WELL API NO. 30-005-20037
5. Indicate Type of Lease STATE ☐ FEE ☐
6. State Oil & Gas Lease No.
7. Lease Name or Unit Agreement Name Cato San Andres Unit
8. Well Number #66
9. OGRID Number 248802
10. Pool name or Wildcat Cato; San Andres

Proposed P&A NOI
State of NM Orphan Well Program
Cato San Andres Unit #66
30-025-20037

**Cato San Andres Unit 66
BLM
March 25, 2025
Conditions of Approval**

Action 453371

State of NM Formerly Cano Petro of NM			PROPOSED
Author:	Abby @ JMR	Well No.	#66
Well Name	Cano San Andres Unit	API #:	30-005-20037
Field/Pool	Cato: San Andres	Location:	660 FSL & 1980 FEL
County	Chaves		Sec 8, T08S, R30E
State	NM	Elevation:	4090' DF
Spud Date	3/2/1967

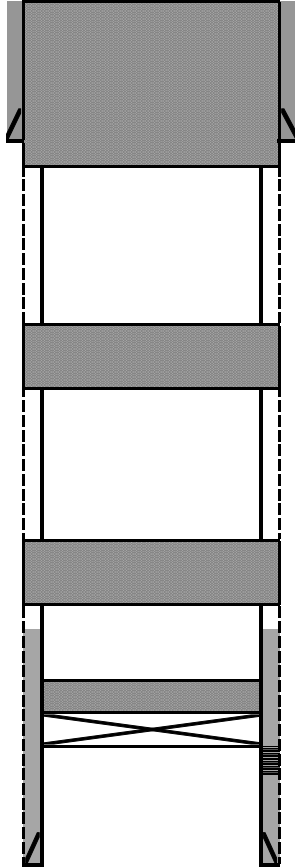
1. Operator shall place CIBP at 3,113' (50'-100' above top most perf) and place a minimum of 50 sx of Class C cement on top to isolate the top of the San Andres Formation. WOC and TAG a minimum of 2,415'.

2. Operator shall perf at 2,250' and squeeze Class C cement to 1,925' seal the Grayburg and Queen Formations. WOC and TAG.
3. Operator shall perf at 1,510' and squeeze Class C cement to 1,390' seal the Yates and bottom of the Salt Formations. WOC and TAG.

4. Operator shall perf at 1,189' and squeeze Class C cement to 881' seal the top of Salt and Rustler Formations. WOC and TAG.
5. Operator shall perf at 584' and squeeze class c cement to surface to seal the 8-5/8" casing shoe.

6. Dry hole marker must be below ground.
7. Surface reclamation will need to be completed once the well bore has been plugged. Please contact rflores@blm.gov for additional information.
